#### 197th session

## Proposal for Supplement 13 to UN Regulation No. 65 (Special Warning Lamps)

### Submitted by the Working Party on Lighting and Light-Signalling\*

The text reproduced below was adopted by the Working Party on Lighting and Light-Signalling (GRE) at its ninety-second session (ECE/TRANS/WP.29/GRE/92, para. 27). It is based on ECE/TRANS/WP.29/GRE/2024/16/Rev.1. It is submitted to the World Forum for Harmonization of Vehicle Regulations (WP.29) and to the Administrative Committee (AC.1) for consideration at their November 2025 sessions.

### Examples of approval mark

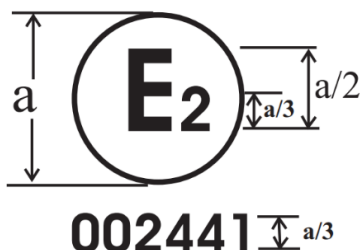
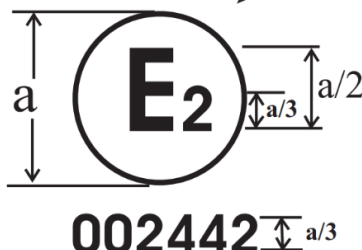
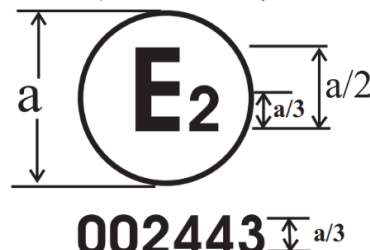
Annex 2, amend to read:
